Airworthiness Directive

| 81-74/2 Schleicher

| Schleicher ASW 19, all models,

| Schleicher ASW 20, all models,

Aileron hinge

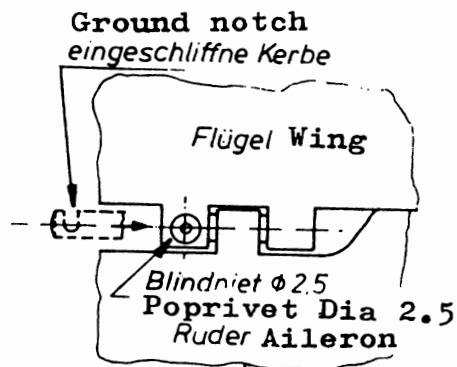
It may be possible that the aileron hinge shaft
is not correctly secured.

Unless already accomplished, check the aileron hinges
prior to next flight after publication of this AD to
see, whether the pop rivet securing the aileron hinge
shaft is in its place (see figure).
The rivet head can be felt under the adhesive tape.
If necessary, remove this tape to facilitate checking.

Action to be accomplished by an approved service
station and to be entered in the sailplane's log.
